RE: 18360 Chelsea Knolls Drive, BAT Plan comment

Re: Chelsea Knolls, Lots 7
Revised BAT Site Plan

BAT SITE PLAN
CHELSEA KNOLLS
LOT 7
18360 CHELSEA KNOLLS DRIVE
ZONING: RC-DEO
TAX MAP No. 12 GRID No. 5 PARCEL No. 7B
FOURTH ELECTION DISTRICT HOWARD COUNTY, MARYLAND
DATE: FEBRUARY, 2015
SHEET 2 OF 2

PRECAST 1 COMPARTMENT PUMP TANK 1500 GALLON CAPACITY
DWG. P-T-15-1

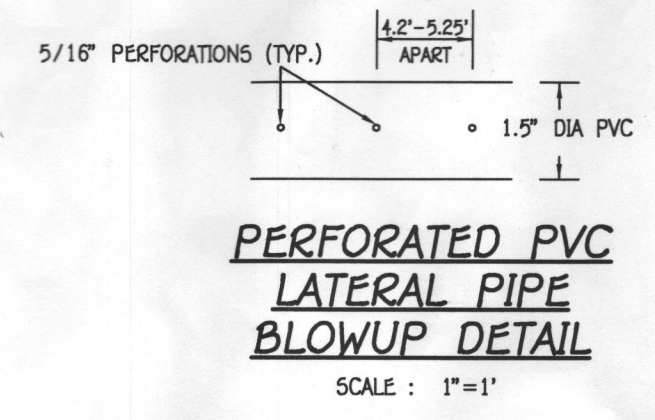
12. Include a label for $\frac{1}{4}$ " perforation in the Force Main inside the Pump Tank, and indicate its position above the ALARM Float.
13. Like recommending too small of a pump causes problems; oversizing the pump can cause problems as well. The pump you should be selecting is the one that has the response curve nearest to your point of intersection for head:discharge with your head:discharge intersection under the curve.
Another thing to consider is that the pump is appropriate for residential use and doesn't require a special circuit. Try for a pump that operates on 115V, single-phase current. Then of course there is cost. There are two pumps that are a closer match to your system than the one you selected, and one of those pumps is 0.3 hp.

14. Add a note stating that any septic system ALARM will be on a circuit separate from any other septic system components or alarms.

12. The weep hole has been shown.
13. As stated above, we did not believe the pump to be too oversized, but recommendation for pump size has been revised as requested on both sheets 1 & 2.

14. Note has been added as requested.

FIGURE 4.1 CENTER FEED MANIFOLD DISTRIBUTION NETWORK

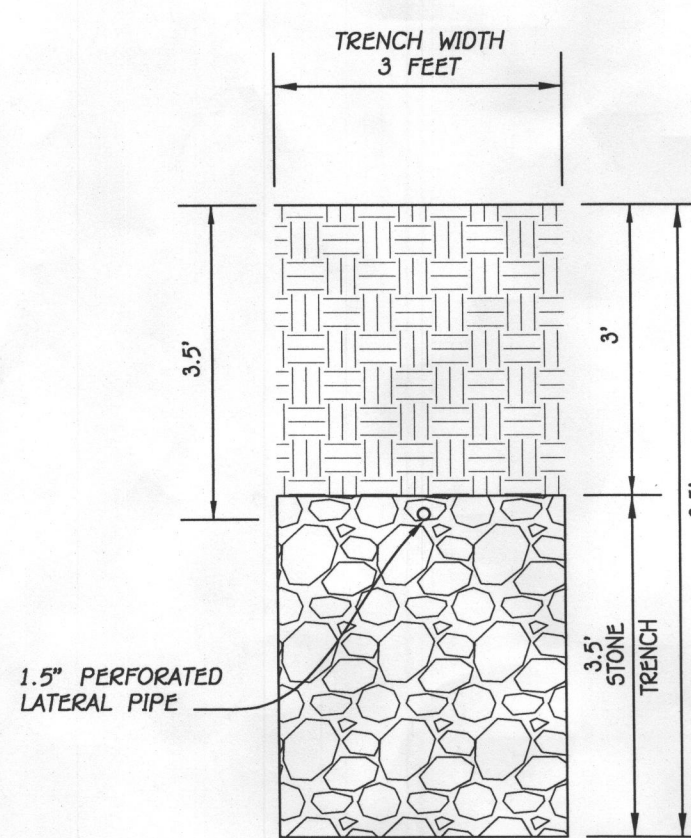
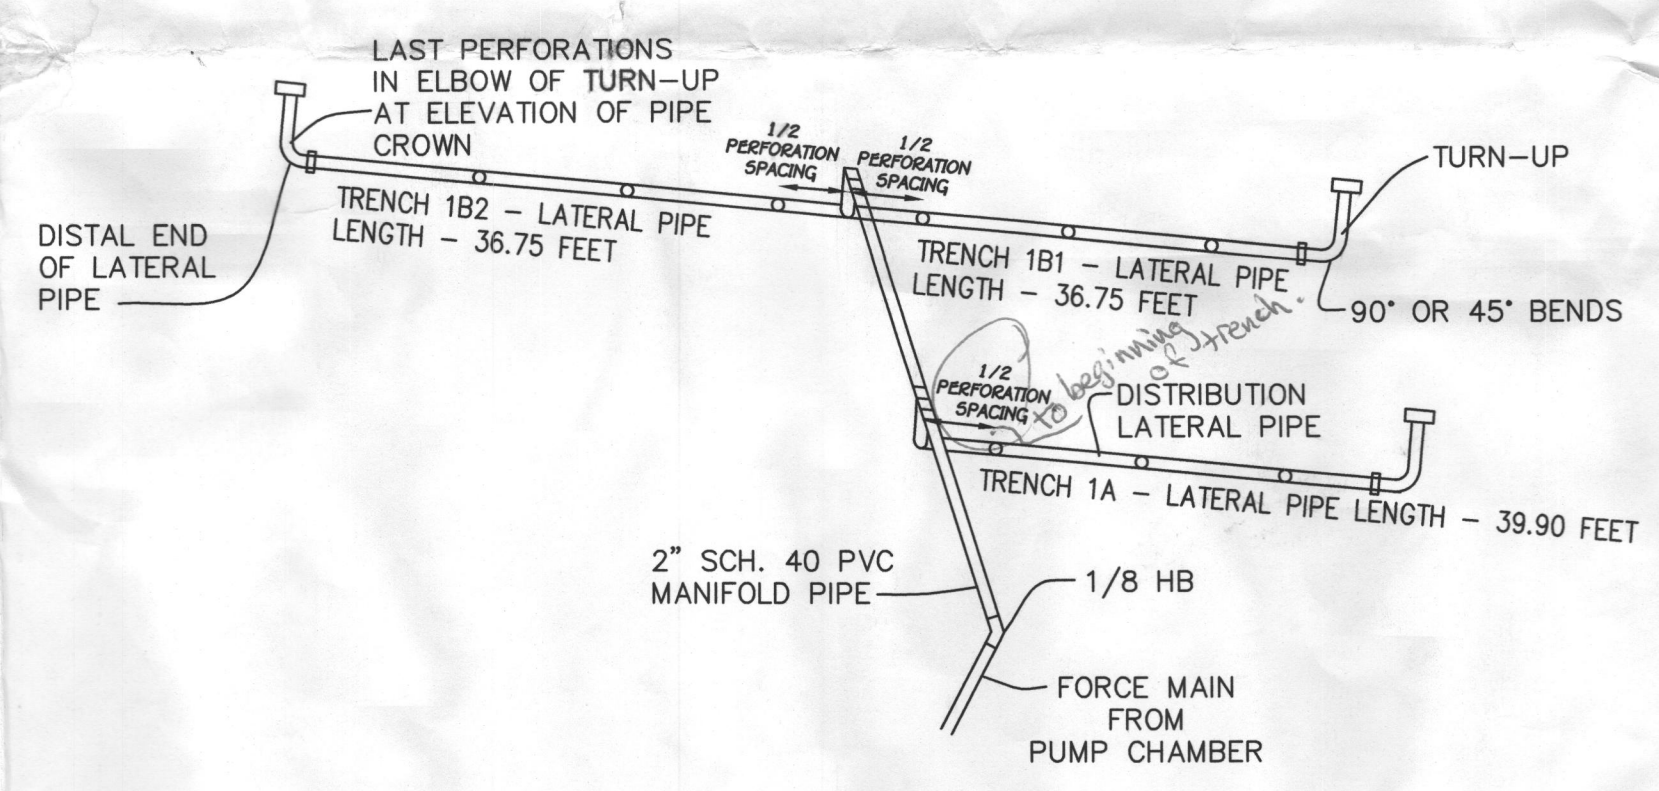
3. In the labels and tables throughout the plan use terms consistently. For example use either 'orifice' or 'perforation' throughout the plan.
4. The detail for the distribution network has incorrect labels for lateral length.

5. Include a label in the detail for the lateral turn-up indicating 'position of end perforation at elevation of pipe crown'.
6. In the Low Pressure Dosing System-Initial Installation table.

7. Re-design laterals 1B1 and 1B2 according to 6.a. above. Correct all tables and details.
8. Add a lateral detail for the end feed lateral as it is different than the center feed. Indicate the beginning of the trench relative to the position of the manifold and lateral.

- a. As you have detail drawings for both types of laterals, specify the perforation interval for each and the $\frac{1}{2}$ perforation distance at the beginnings and ends of the respective laterals.

3. Labels have been made consistent.
4. Unfortunately the trench length was labeled instead of the pipe length. The lengths have been corrected.
5. Although this label was already shown in the center feed layout, this note has been also added to the turn up detail.

7. Laterals have been redesigned as requested.
8.
 - a. Lateral feed layout has been added as requested.
 - b. Replacement system design has been removed.
